PRELIMINARY DRAINAGE REPORT  
FOR

**SCOTTSDALE CONDO VILLAS**  
NWC OF MILLER ROAD & OSBORN ROAD  
SCOTTSDALE, ARIZONA

Plan # \_\_\_\_\_  
 Case # 26-DR-2015  
 Q-S # \_\_\_\_\_

**DRAINAGE REPORT RESUBMITTAL INFORMATION:** The drainage report is not approved. Please address the following issues.

**SCOTTSDALE CONDO VILLAS**  
3510 NORTH MILLER ROAD  
SCOTTSDALE, ARIZONA  
**PRELIMINARY DRAINAGE MAP**

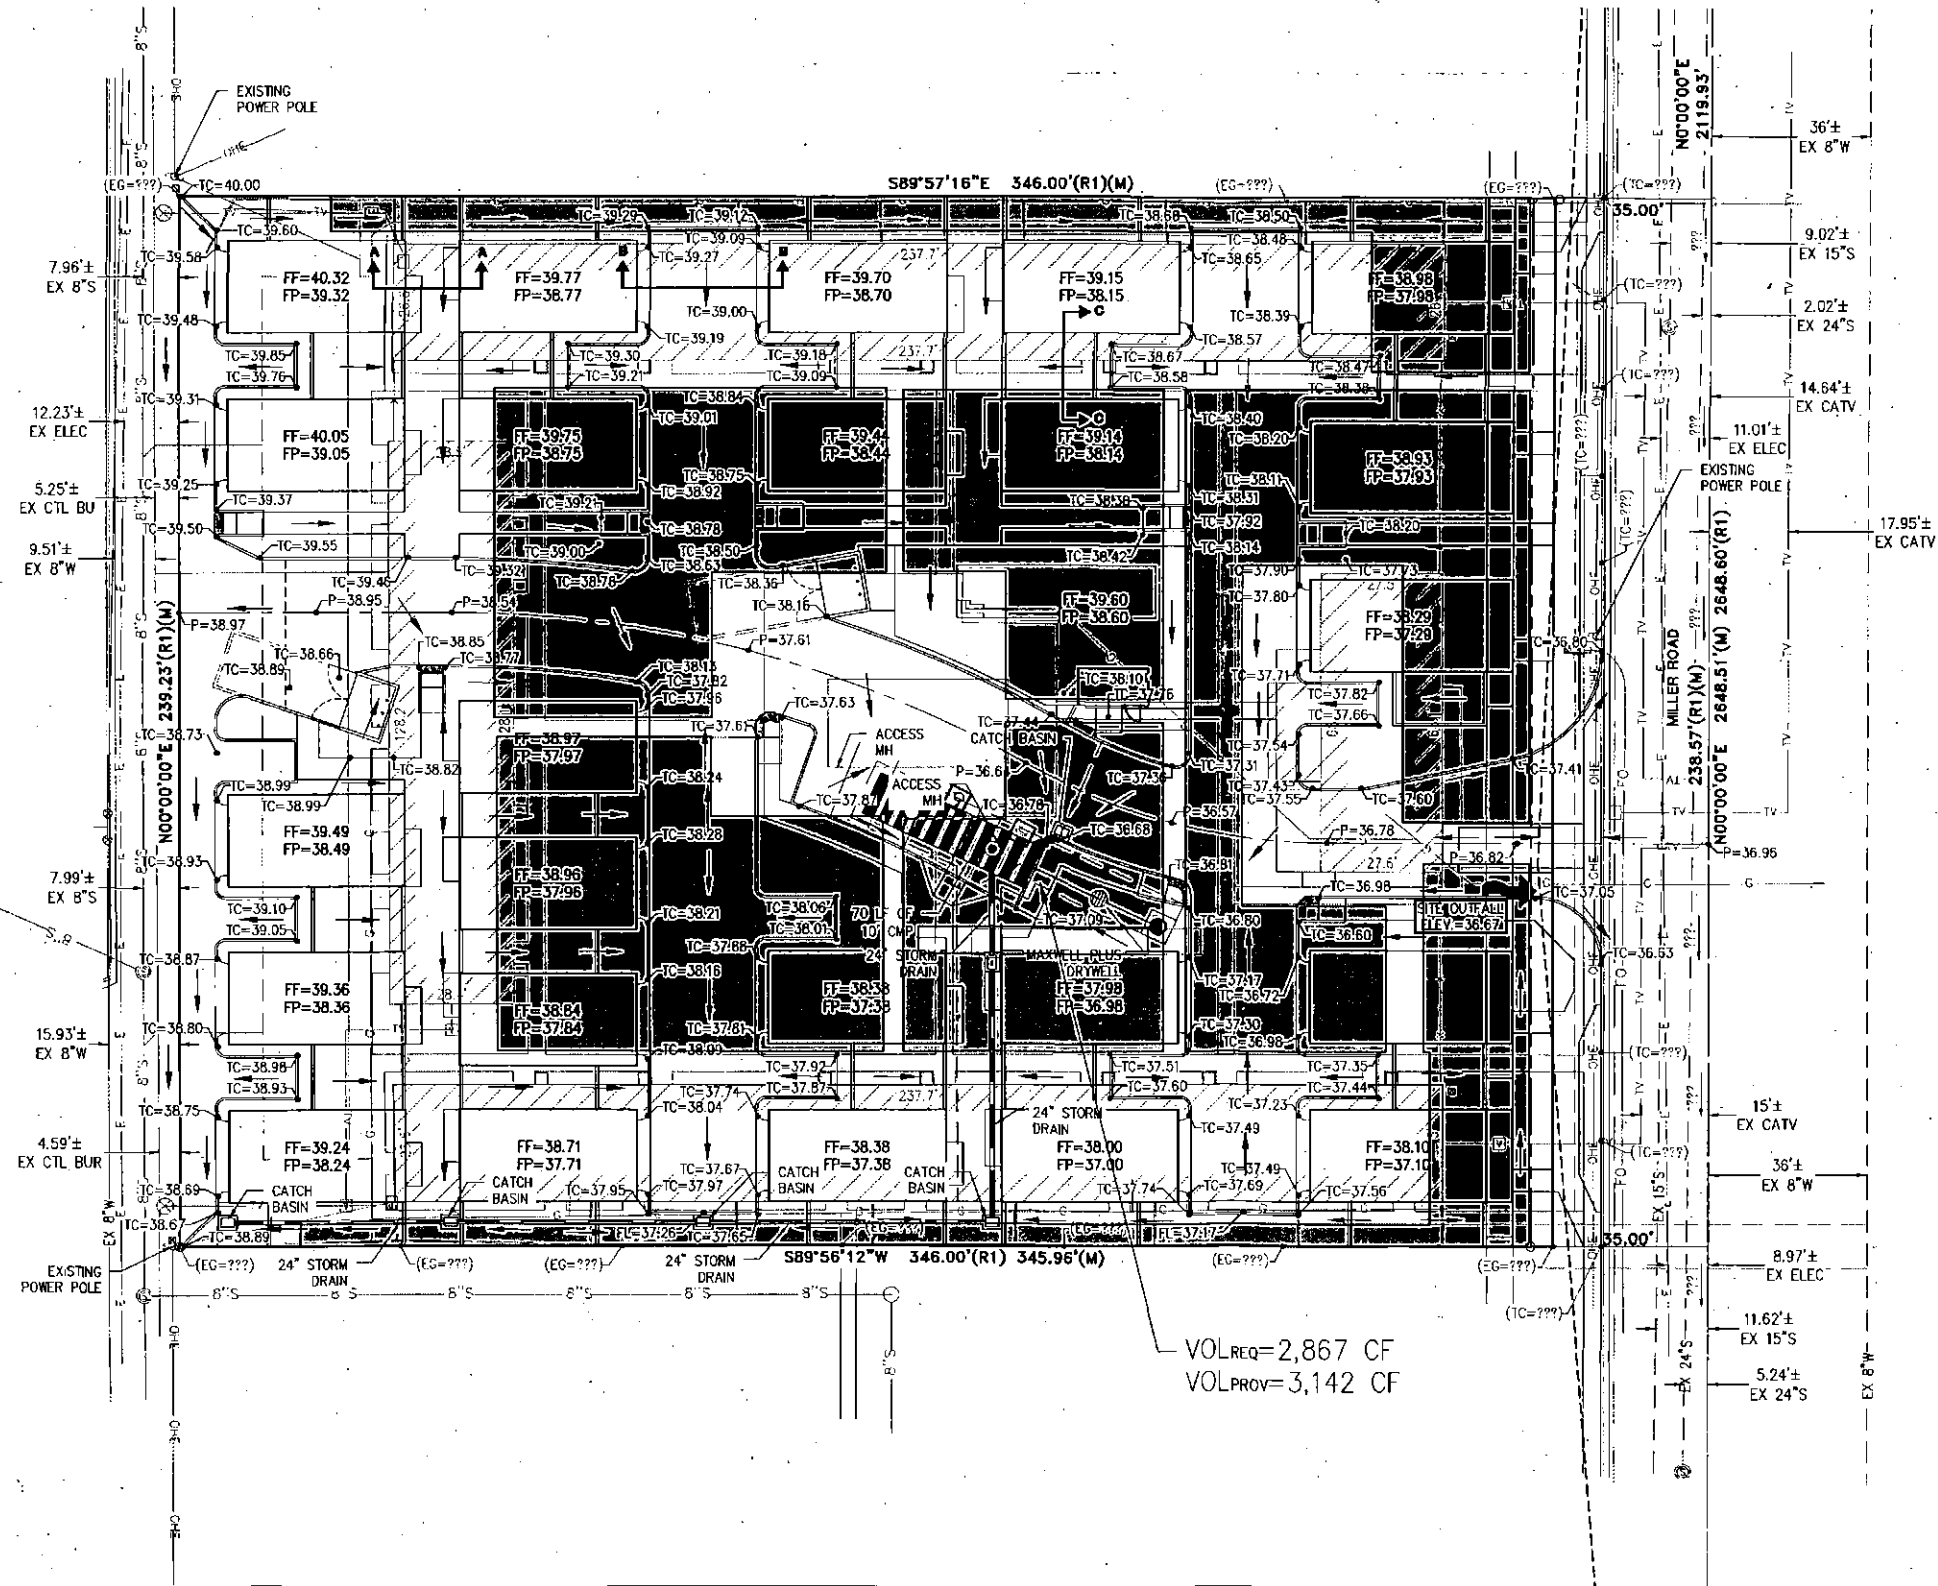
3. **POST DEVELOPMENT DRAINAGE SITE PLAN: DS&PM CHAPTER 4, Section 4-1.800 and 4-1.900** Please provide a full size, 24"x36" POST development site plan. Show and label the contours to at least 10 ft beyond the property lines. Show and label all the basic elements of a drainage plan including: existing and proposed contours or elevations, flowrates, flowlines, existing storm drainage infrastructure and all existing easements Show and label the onsite drainage basins and within each basin show the pre development Q10 and Q100 for each historical runoff entry and exit location, show and label concentration points. Use drainage flow arrows to show direction of runoff.

1. **DRAINAGE SUB AREAS: DS&PM CHAPTER 4, Section 4-1.800** Demonstrate how onsite runoff will get to the detention basins/pervious areas. Use bold lines to delineate the drainage sub areas and show all grade breaks on the G&D plan. Calculate the volume required and volume provided in each drainage sub area. Demonstrate that on-site stormwater runoff from each drainage sub area is accounted for in specific drainage detention basin. Calculate and show the percentage runoff that is contributed from each drainage sub area to a specific drainage basin. Use a table or spreadsheet format to show the results in the report.
